REPORT ON THE "ALISO CANYON FAULT"
AND THE ALLEGED "MOUNTAIN TOP FAULT ZONE"
CAMP PENDLETON, CALIFORNIA

November 25, 1981

SOUTHERN CALIFORNIA EDISON COMPANY AND
SAN DIEGO GAS AND ELECTRIC COMPANY

RESPONSE TO QUESTIONS

Figure 13.3--Epicenter location of the November 1981 swarm projected onto the reflection profile G-G' of Greene and Kennedy. The arrow indicates the epicenter of the largest event ($M_L=3$) discussed in the response to question 1. The swarm clusters around this location with a radius of about 1 km.

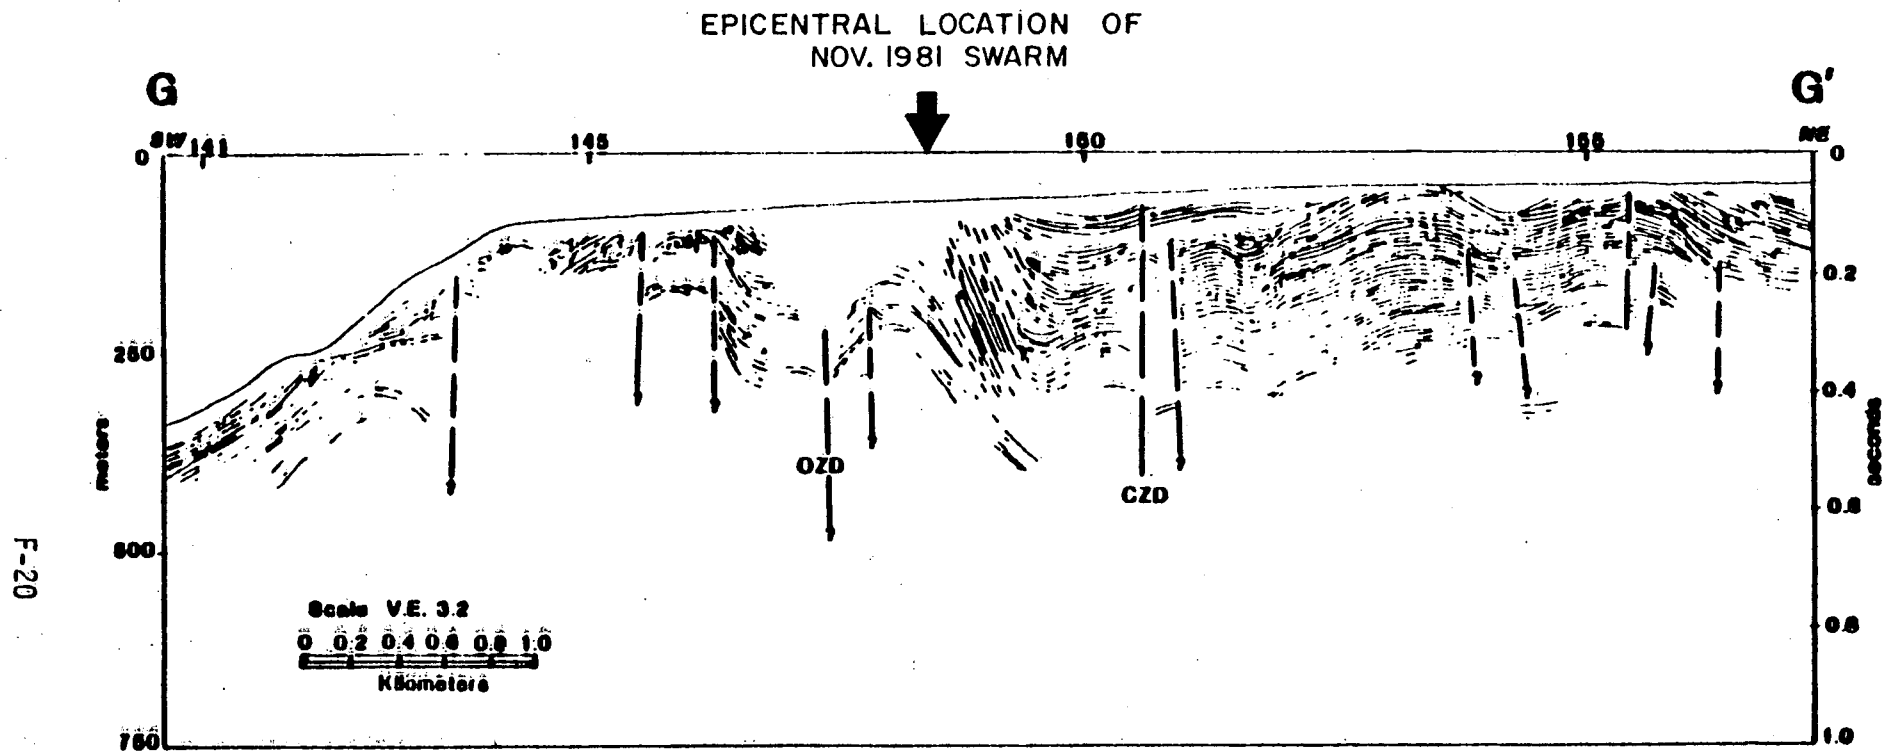
13. What observations can be made concerning the CZD and the swarm if the Greene and Kennedy map is representative of the geologic conditions?

Greene and Kennedy have presented several line-drawing cross-sections constructed from the numerous reflection profiles from the offshore area. Their profile G-G (SER, Appendix F, p. F20) is the closest profile to the recent swarm. We have projected the epicentral location of the largest event ($M_L=3$), along the strike of the anticline about 1 km as shown on Plate 1 of Greene and Kennedy, onto this profile, Figure 13.3. As discussed in the response to Question 1, the swarm surrounds this epicentral location with a radius of about 1 km. Considerations of this cross-section strengthens the conclusion that the swarm was associated with the OZD.
